ACTEWAGL DISTRIBUTION

Review of AER Draft Decision - REPEX

RO004300RP0003 | Final v.3

January 2015

Figure 8 Revised HV cable age distribution based on establishment date of suburbs

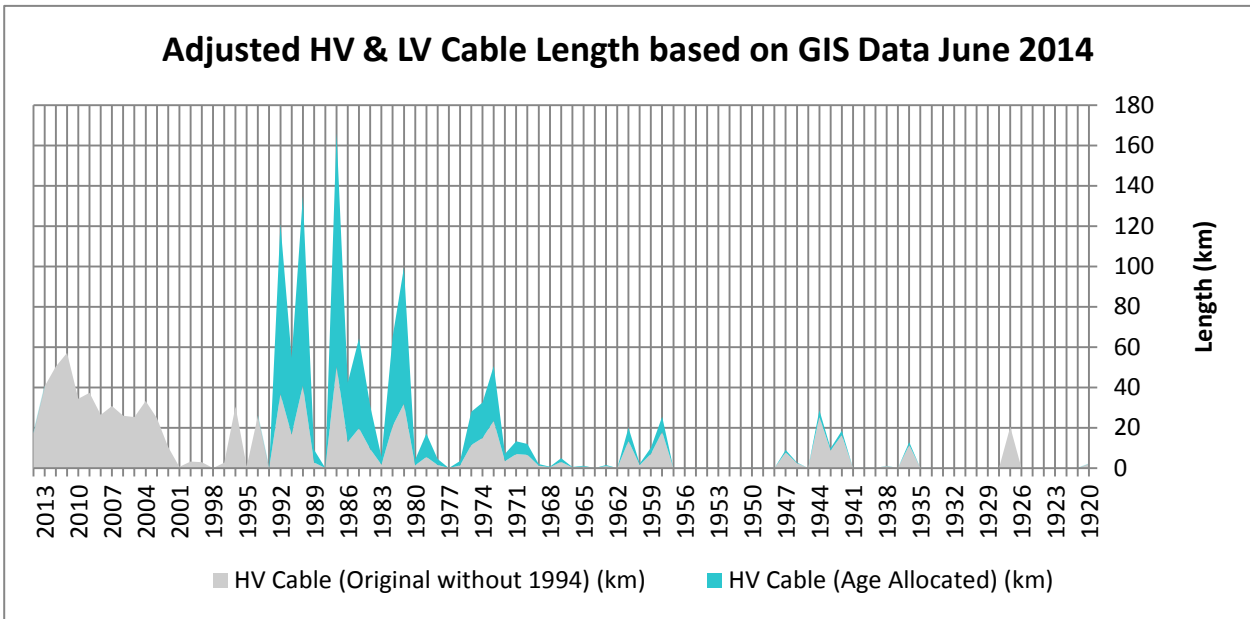
The above reference is no doubt based on the graph shown in Figure A-14⁹ of the draft decision document, which shows a large 'spike' in cables installed about 20 years ago in 1994. This spike is not 'real', as it represents a large proportion of ActewAGL Distribution's underground cables, which had unknown ages at the time when the data was first loaded into the GIS system.

The revised asset age profile is contained in Figure 8 below:
